1. In this Final Rule, to meet our responsibility under sections 205 and 206 of the Federal Power Act (FPA)<sup>1</sup> to remedy undue discrimination, the Commission adopts standard procedures and technical requirements for the interconnection of large wind plants. The Commission requires all public utilities that own, control, or operate facilities for transmitting electric energy in interstate commerce to append to the Large Generator Interconnection Procedures (LGIPs) and Large Generator Interconnection Agreements (LGIAs) in their Open Access Transmission Tariffs (OATTs) the Final Rule Appendix G adopted here. These standard technical requirements provide just and reasonable terms for the interconnection of wind plants.<sup>2</sup> The rule recognizes the technical differences of wind generating technology, and benefits customers by removing unnecessary obstacles to further development of wind generating resources while ensuring that reliability is protected.

#### D. Wind Plant Interconnection Modeling

**Appendix G—Interconnection Requirements for a Wind Generating Plant**

**Figure 1 Proposed low voltage ride-through standard**

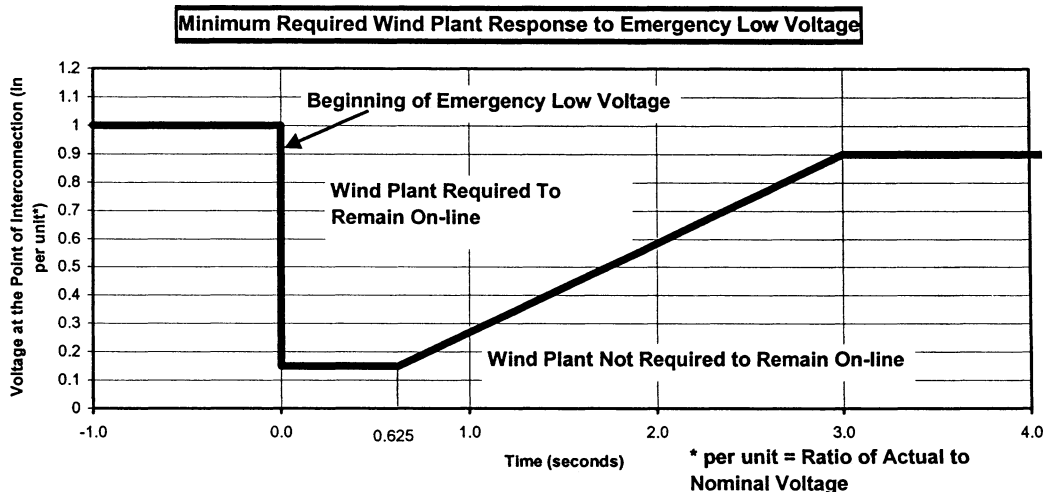
18. Several commenters, including AWEA,<sup>19</sup> Western, FirstEnergy, and the Midwest ISO, state that they support the low voltage ride-through standard in Figure 1 of the NOPR. Midwest Reliability Organization suggests, however, that the standard could be in article 9.6 of the LGIA. CenterPoint contends that the reliability concerns presented by the failure of a large wind plant to ride through a low voltage event also exist if other generators also fail to ride through such events, and thus would apply a low voltage ride-through requirement to all generators. Western supports the standard as proposed, with the understanding that it may need to be modified later if it causes unforeseen problems on the transmission system.

20. Additionally, several entities dispute the specific time periods and associated voltage levels set forth in Figure 1 of the proposed Appendix G. American Superconductor states generally that the proposed low voltage ride-through curve in Figure 1 of the NOPR is unrealistic and does not resemble voltage situations that wind plants are likely to encounter. It also argues that the low voltage requirement proposed in the NOPR is not comparable to what is required of conventional generators. Midwest ISO TOs, CenterPoint and Xcel assert that requiring the low voltage ride-through capability to go only to 15 percent of the rated line voltage (as set out in Figure 1 of the NOPR) may be too high and may present reliability problems. They recommend that the Figure 1 low voltage ride-through profile require the wind turbine to ride through low voltage at zero percent of the rated line voltage for 150 milliseconds. NUSCo recommends that the Commission require wind generators to ride through a fault with zero percent of the rated line voltage at the point of interconnection for 250 milliseconds (15 cycles). American Transmission argues that the low voltage ride-through curve of Figure 1 should show the voltage to be at 0.90 per unit prior to time zero. ISO New England states that to the extent the Commission adopts a low voltage ride-through requirement, it should require wind plants to remain connected to the transmission system for a zero voltage level for the time period associated the typical time it takes to clear a normal design contingency fault.<sup>20</sup>

35. With respect to Midwest ISO TOs' concern that Appendix G, Figure 1 does not contain information on how the standard would apply to unbalanced voltages in close proximity to the point of interconnection,<sup>25</sup> we note that it is impossible to identify all possible conditions and circumstances that may arise on the transmission system. The low voltage ride-through standard is a general one that will be adequate under most circumstances. We recognize that special circumstances may occur. These may be identified by the System Impact Study, which should identify any additional protection requirements in addition to this standard. We also note that, as discussed below, the Commission permits variations from the Final Rule Appendix G that are "consistent with or superior to" the standard provisions, that are based on regional reliability council requirements, or that are offered by independent entities such as Regional Transmission Organizations (RTOs) or Independent System Operators (ISOs).

36. Similarly, we are not persuaded to alter the specific time periods and associated voltage levels in Figure 1 of the NOPR Appendix G. The low voltage ride-through standard proposed in that figure and adopted here is close to the standard used in other countries and was presented to the Commission by representatives of the wind industry as an achievable requirement. Several commenters, including Transmission Providers, support the standard as one that would safeguard reliability. The Western Electricity Coordinating Council (WECC), a regional reliability council, has approved a similar low voltage ride-through standard. The standard we adopt in this Final Rule is an international standard that has been accepted for use by the Alberta Electric System Operator and Germany, and was developed following detailed study. We do not believe it would be appropriate to deviate from such a widely-accepted

32. We also clarify certain portions of the low voltage ride-through standard. First, we clarify that the low voltage ride-through requirement, and the time periods and associated voltage levels set forth in Appendix G, Figure 1, apply to three-phase faults.<sup>23</sup> This is because three-phase faults are the most severe, whereas two-phase or single-phase faults drop the voltage to a level not as low as that specified in Figure 1. Further, in response to AWEA, we clarify that a wind plant is not required to satisfy the standard in Appendix G, Figure 1 if the wind plant is intentionally tripped off line following a fault under a "special protection scheme"<sup>24</sup> agreed to by the Transmission Provider. These situations may include a fault on the Transmission Provider's side of the Point of Interconnection, as well as a fault other than a three-phase fault covered by the low voltage ride-through standard.

A wind generating plant shall be able to remain online during voltage disturbances up to the time periods and associated voltage levels set forth in the standard in Figure 1, below, if the Transmission Provider's System Impact Study shows that low voltage ride-through capability is required to ensure safety or reliability.
